# PARTS & SERVICE NEWS

REF NO.	AA99041
DATE	Feb. 1, 1999

**SUBJECT:** INTRODUCTION OF IMPROVED TRANSMISSION SWITCH F/R LEVER

**PURPOSE:** To introduce an improved F/R lever of the transmission control switch featuring longer service life.

In cases of WA100-3 thru WA250-3 (WA330-3 Excel and WA320-3 vehicles being produced by KCCM and in turkey)

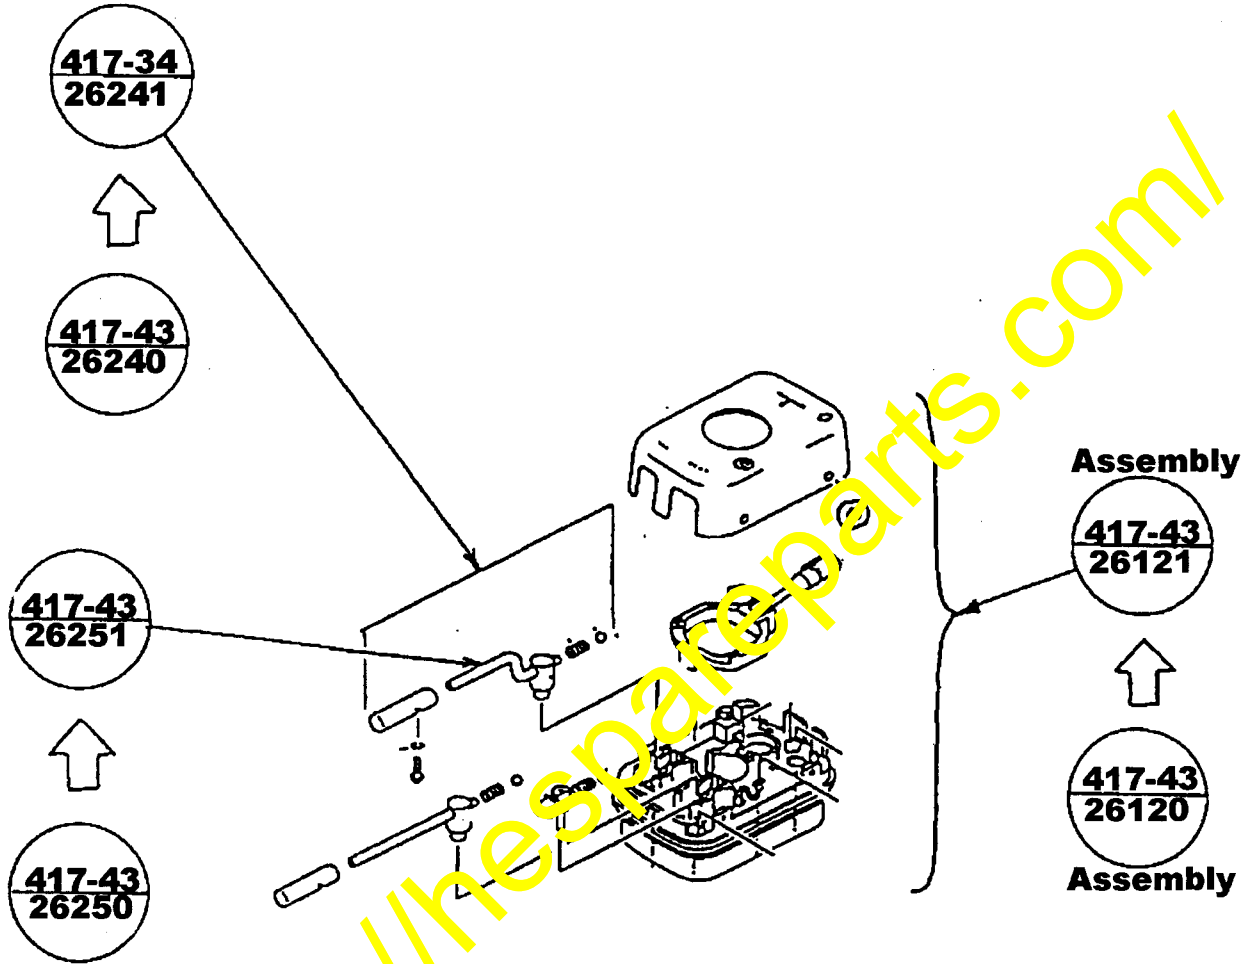
The junction method for the F/R lever, which is apt to be operated quite frequently, to the roller boss has been modified as illustratively explained below to improve its service life.

When making this modification to enhance the service life of the F/R lever, replace the following parts.
